Project Details: Units 5A-C, Second Avenue.

Proposed 1st Floor Plan

For planning amendment Project - System - Spatial Zone - Level - Type - Originator - Role - Number Revision

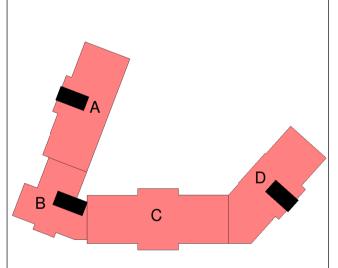
1.) Reconfiguration of the approved basement layout.

2.) Removal of consented core & re-configuring of internal space.

Ground floor alterations proposed to facilitate the introduction of a larger commercial unit capable of accommodating a small supermarket.

4.) Consented creche re-located to block C.

5.) Consented substation & switchroom relocated to

6.) Amalgamation and consolidation of communal

7.) Core C omission and associated alterations to Blocks C and D.

8.) Common corridor reduced to 1350mm from

9.) Party Wall moved 803mm to accommadate array of 1 bedroom apartments in lieu of 2 central studio

10.) New studio apartment type.

11.) New one-bed apartment type.

12.) New two-bed apartment type.

13.) Minor alteration to previously approved facades, building line and internal partition walls and slight increase apartments nos.
